STAFF REPORT

SPECIAL PERMIT AMENDMENT APPLICATION NO. SPA 73-P-068-02

APPLICANT: Trustees of Grace Orthodox Presbyterian Church

LOCATION: 2371 & 2381 Cedar Lane, Vienna, 22180

Pre-Development Critical Root Zone & Tree Protection Map

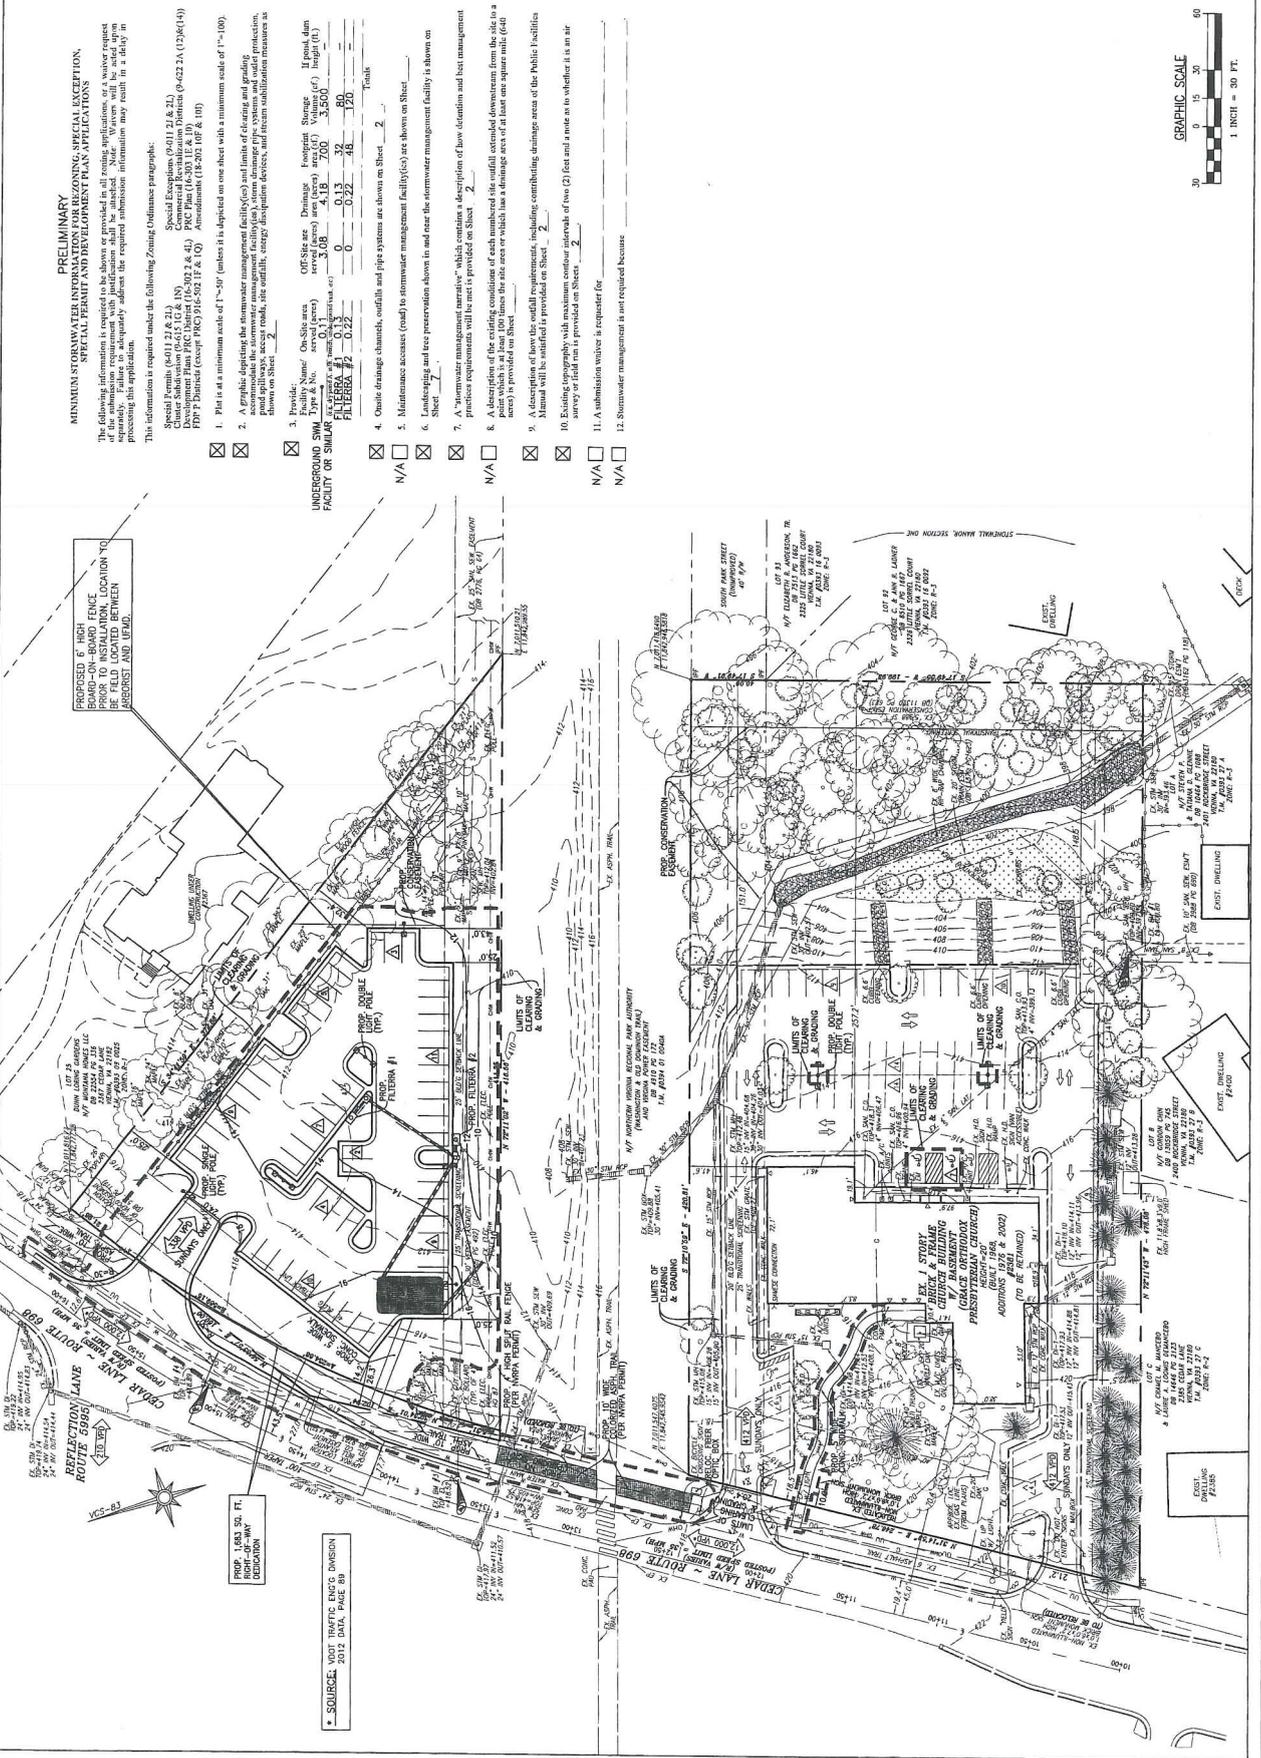
2. **Comment:** The 'Pre-Development Critical Root Zone & Tree Protection Map' is not legible and cannot be reviewed.
